**Environmental
Planning
Commission**

Staff Report

Agenda Number:4
Project #: PR-2020-004086
Case #: SI-2020-00690
Hearing Date: September 10, 2020

Agent	Consensus Planning, Inc.
Applicant	Titan Property Management, LCC
Request	Site Plan – EPC and Variance - EPC
Legal Description	Tract 1 The Foothills
Location	Tennyson Street NE (E-22)
Size	16.05 acres
Existing Zoning	R-MH

Figure 4. Proposed 5-foot setback at the southeast corner of the site with future AMAFCA Access Road highlighted in green.

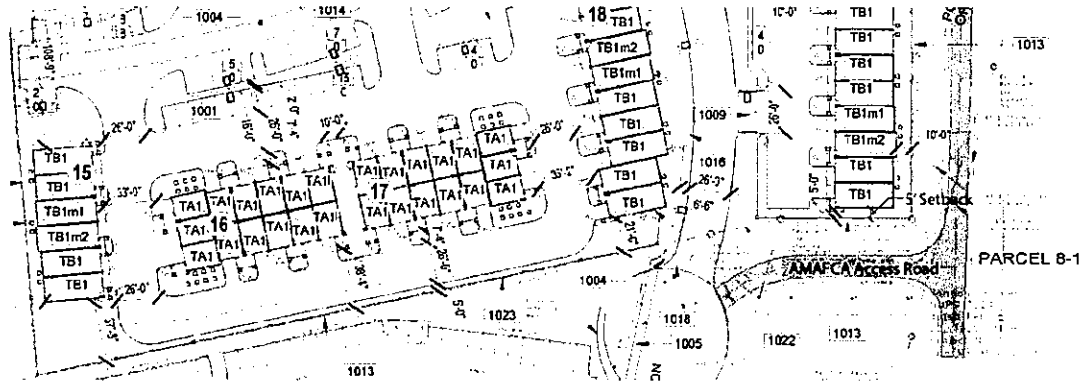
Further, front lot lines usually border a street along their entire width; however, the south property line only borders Tennyson Street for a small portion of its width, while the remainder borders adjacent properties. Any other similarly situated property at the end of a cul-de-sac would treat the lot line extensions from the cul-de-sac and adjacent to other properties as side lot lines. If that were the case, no variance would be required because the side setback requirement is only 5 feet (see Figure 4).

The intension of this buffer or single-loaded street is to provide a meaningful separation and transition between development on the site and the MPOS. That separation is more than provided by the four lanes of Tramway Blvd. Between the buildings and the eastern property line as designed, there is only about 360 linear feet of the 760 feet where the buffered setback is less than 20 feet.

4. The applicant is requesting two variances as shown and noted on the Site Plan - EPC: 1) 10 feet of the 15-foot front setback at one building; and 2) 10-foot variance of the 20-foot buffer between the MPOS.

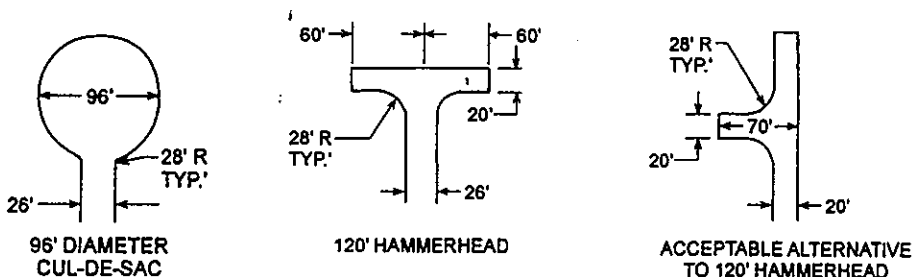
- Right-of-way boundaries are unclear on the site plan.

This will be clarified.
